## Report to the Planning and Zoning Commission

<b>Case:</b>	S2019003 – Azure Canyon
<b>Hearing Date:</b>	September 26, 2019
<b>Supervisor District:</b>	4
<hr/>	
<b>Applicant:</b>	Zach Hilgart, HilgartWilson
<b>Owner:</b>	J and A Camelback Property, LLC
<b>Request:</b>	Preliminary Plat containing 333 lots, 30 tracts, and 4 parcels in the R1-18 RUPD and R1-10 RUPD zoning districts
<b>Site Location:</b>	Approximately at the northwest corner of 181 <sup>st</sup> Ave. and Camelback Rd. in the Glendale area
<b>Site Size:</b>	Approx. 143 acres
<b>Density:</b>	2.33
<b>County Island:</b>	Yes (City of Glendale)
<b>County Plan:</b>	White Tank/Grand Avenue Area Plan – Small Lot Residential (2-5 d.u./ac.)
<b>Municipal Plan:</b>	City of Glendale – Low Density Residential (0-1 d.u./ac.)
<b>Municipal Comments:</b>	None received to date
<b>Recommendation:</b>	<b>Approve with conditions</b>

Key Map for Azure Canyon Preliminary Plat

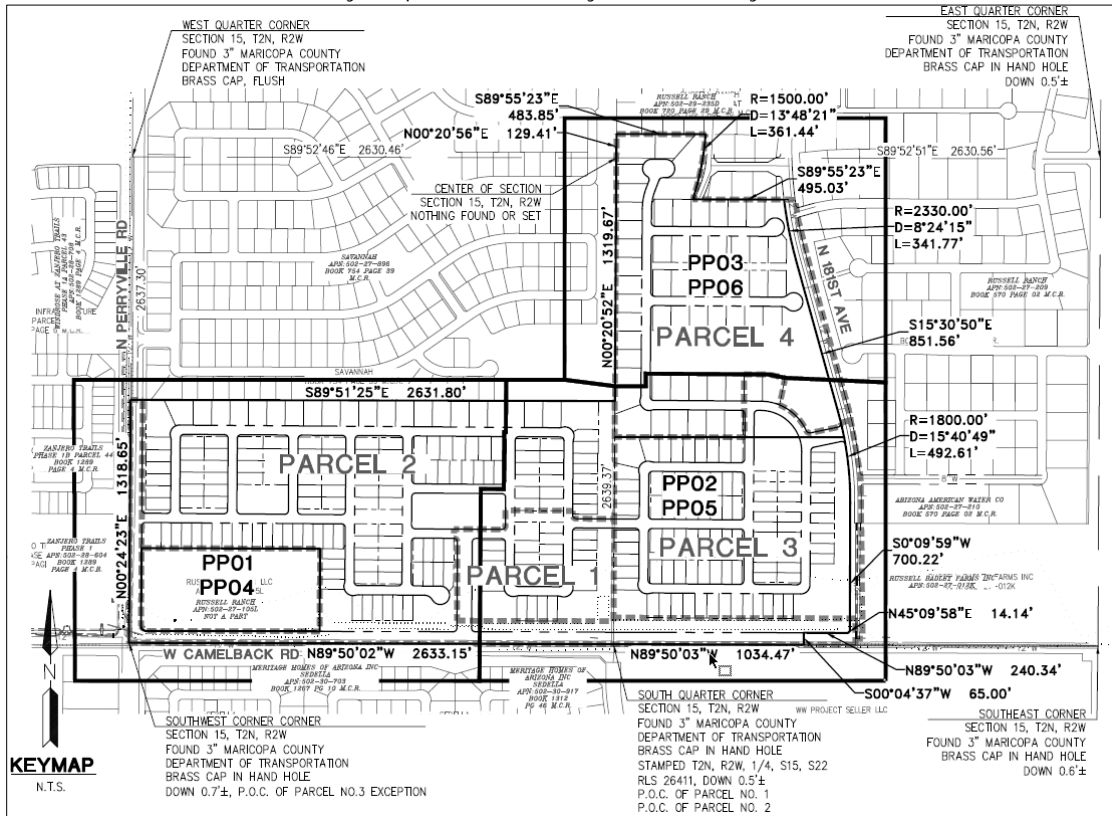
- The preliminary plat provides a balance of open space while accommodating stormwater from the existing Russell Ranch Units 1, 2 and 3. The applicant states that the existing plats of Russell Ranch include 7% open space and would provide for a neighborhood park, pocket parks and an internal trail system to account for 23.3% of the total gross acreage of Azure Canyon. The applicant states the neighborhood park would be constructed with the first phase of development. Amenities would include tot lots, playgrounds, ramadas, barbeque, and benches. Landscaping includes two turfed areas and a variety of drought tolerant trees, accents, shrubs and groundcover. The development parcels acreage and percentage of open space are identified below:
